# Access Compliance Report

## Public Rights-of-Way

Intersection ID: 53092	Main Street: ALEXANDER_RD	Cross Street: DEERHURST_LN	Location: SE
ADA ID: D27A39F3E5BB	Ramp Type: BlendTrans1	Initial Pass/Fail: Fail	Overall Compliance: No
Severity Score: 21.25			
Codes/Mitigation Info/Possible Solution		Field Measurements/Component Compliance

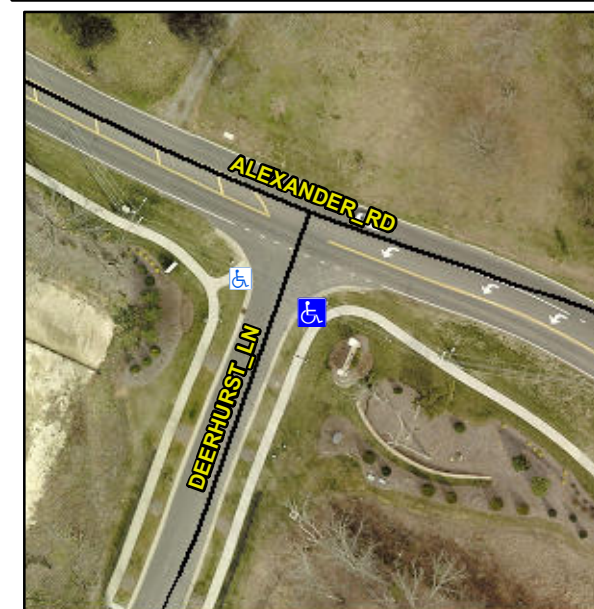
**R304.5.1, R304.5.3**

Compliance	Description	Data	Compliance	Description	Data
N/A	Ramp Length (in)	97.0	Yes	BlendTrans Slope (%)	1.3
No	Ramp Width (in)	47.0	No	BlendTrans XSlope (%)	5.3
N/A	Flare Type LT	N/A	N/A	Flare Type RT	N/A
N/A	Flare Slope LT (%)	N/A	N/A	Flare Slope RT (%)	N/A
N/A	Flare Traversable LT?	N/A	N/A	Flare Traversable RT?	N/A
N/A	Landing Length (in)	N/A	N/A	DWS Provided?	N/A
N/A	Landing Width (in)	N/A	N/A	DWS Contrast?	N/A
N/A	Landing Slope (%)	N/A	N/A	DWS Length (in)	N/A
N/A	Landing X Slope (%)	N/A	N/A	DWS Full Width?	N/A
N/A	Landing Curb? (Y/N)	N/A	N/A	DWS Offset (in)	N/A
N/A	Shared Landing?	N/A			
N/A	Gutter Ponding?	N/A	N/A	Gutter Slope (%)	N/A
N/A	Gutter Lip Ht (in)	N/A	N/A	Gutter X Slope (%)	N/A
N/A	Painted X Walk1?	No	N/A	Painted X Walk2?	No
	X Walk 1 Direction	To N		X Walk 2 Direction	To NW
	X Walk 1 Width (in)	N/A		X Walk 2 Width (in)	N/A
	X Walk 1 Slope (%)	6.3		X Walk 2 Slope (%)	2.3
	X Walk 1 X Slope (%)	3.4		X Walk 2 X Slope (%)	3.8

N/A	Ramp inside XWalk1?	N/A	N/A	Ramp inside XWalk2?	N/A
	Road Slope (%)	1.6		Clear Space?	N/A
	Road X Slope (%)	5.2	N/A	Clear Space to XWalk (in)	N/A
N/A	Any Obstructions?	N/A	N/A	Storm Grate/Utility Hazard?	N/A
	Obstruction Type			Storm Grate/Utility Type	
		N/A			N/A
		Yes		Surface Condition? (G/P)	Good
		N/A		Curb Slope (%)	2.8

**Remove & Replace Curb Ramp With Two New Directional Ramps or Equivalent.**
